Office Action Summary

10/038,678

TAGUCHI ET AL.

DETAILED ACTION

FIG. 15

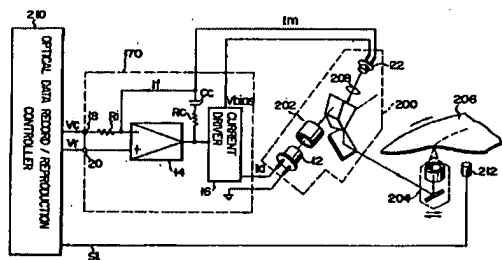
3. Claims 7-20 are rejected under 35 U.S.C. 102(b) as being anticipated by Taguchi (5,097,473). Taguchi discloses the claimed invention. Note figure 15 which shows a semiconductor laser (12), a light intensity detection element (22), an amplifying circuit (14) a laser drive circuit (16), and a modulation signal current generating section (210) for outputting a modulating signal current (record pulse signal, see col. 11 lines 32-57, below) to the reversal input terminal (-) of the amplifying circuit (14).
